# PARTS & SERVICE NEWS

REF NO.	AT01045
DATE	May 15, 2001

**SUBJECT:** IMPROVEMENT OF FAN TENSIONER ON HD785-5, HD985-5 (SA12V140-1 ENGINE)

**PURPOSE:** To introduce modification procedures to improve the fan belt tension device on HD785-5 and HD985-5 dump trucks and other vehicles (with SA12V140-1 engines)

#### 2. When replacing belt with new belt

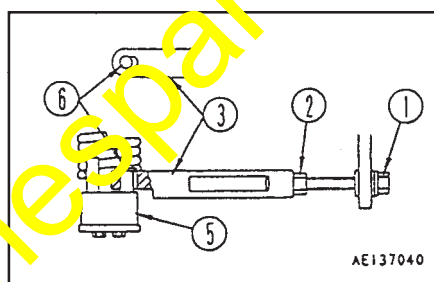
The Operation and Maintenance Manual should be revised as follows.  
(Prints in bold letters are the corrections.)

3. Run for one hour, then check the clearance between the end of the oblong hole of yoke 3 and pin 6 of tension pulley 5.

If there is any clearance,

Tighten adjustment bolt 1 until the clearance is 0 mm (0 in) between the end of the oblong hole of yoke 3 and pin 6 of tension pulley 5, then tighten further three turns. Tighten locknut 2 to hold in position.

**Tighten adjustment bolt 1 until the clearance becomes 0 mm (0 in) before tightening further by 1.5 turn.**

If the fan belt makes any abnormal noise, adjust in the same way.

Change the circled parts

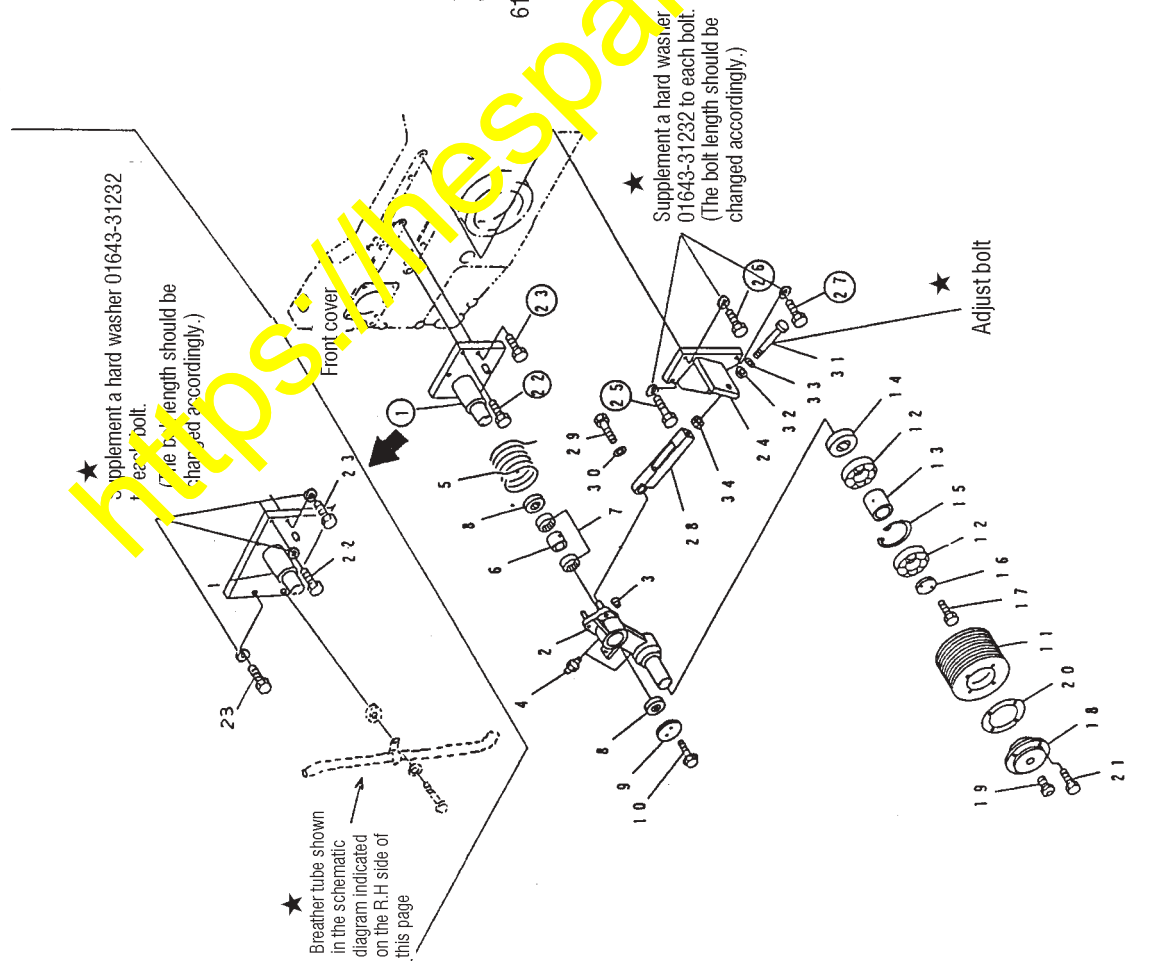
- (1) Supplement a hard washer to each bracket (shaft) mounting bolt.
- (2) Change the number of using bolts from 3 to 5.
- (3) Change the breather tube on the R.H bank.
- (4) Change the adjusting method for the auto tensioner adjust bolt.

Modification in the neighborhood of the tensioner

Modification in the neighborhood of the breather

Tightening torque ranges for the bolts  
 M10 bolts: 6 - 7.5 kgm (59 - 74 Nm)  
 M12 bolts: 10 - 12.5 kgm (98 - 123 Nm)
